REMARKS

Title: REORIENTABLE PULLEY SYSTEM
Inventor: Ryan Stone
Docket No.: 13914.692 Express Mail: EV 384065151US

FIG. 1

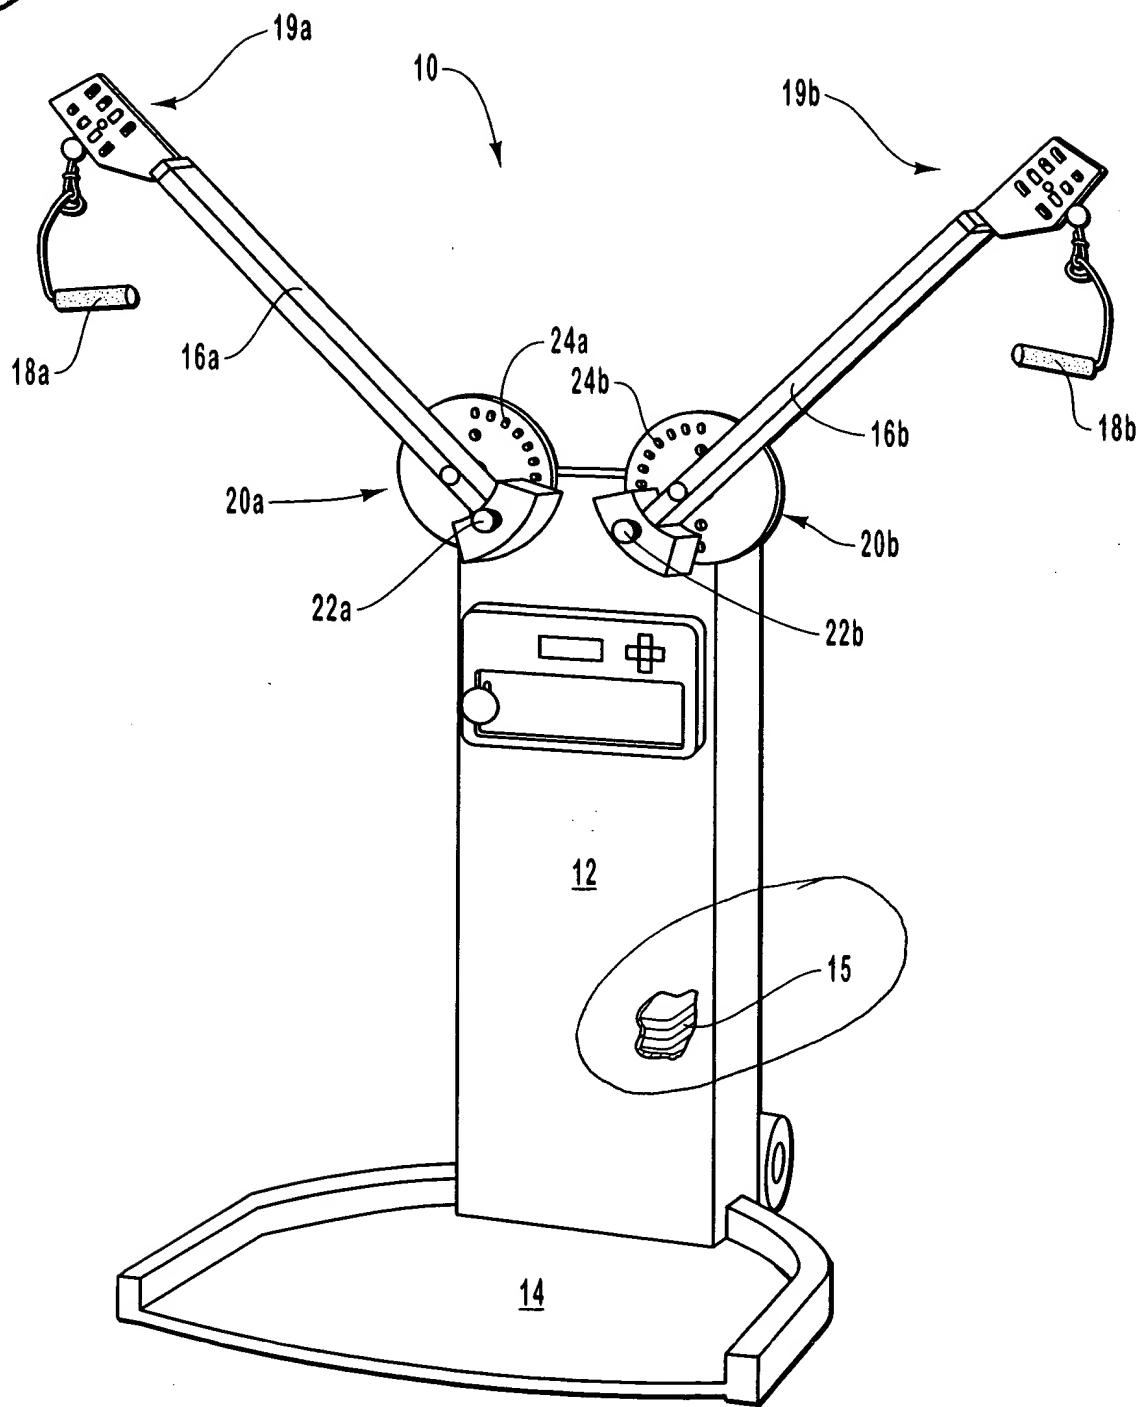
The First Office Action presents an objection to the drawings under 37 CFR 1.83(a). A proposed drawing correction specifically showing a weight stack 15 is included herein. Basis for the amendments to the drawings is found within the drawings and throughout the specification, including the patent incorporated therein by reference, U.S. Patent No. 6,238,323 (see p. 8, line 23). For example, as mentioned above, the specification specifically refers to a resistance assembly being coupled to the cord at page 12, line 19: "First end 54 of cord 53 can be coupled to the resistance assembly, e.g., a weight stack." Also, placement of the reference numeral 61 is shown in Figure 2 (see Specification, page 13, lines 1-2). Accordingly, it is respectfully submitted that the objections of the drawings under 37 CFR 1.83(a) should now be reconsidered and withdrawn.
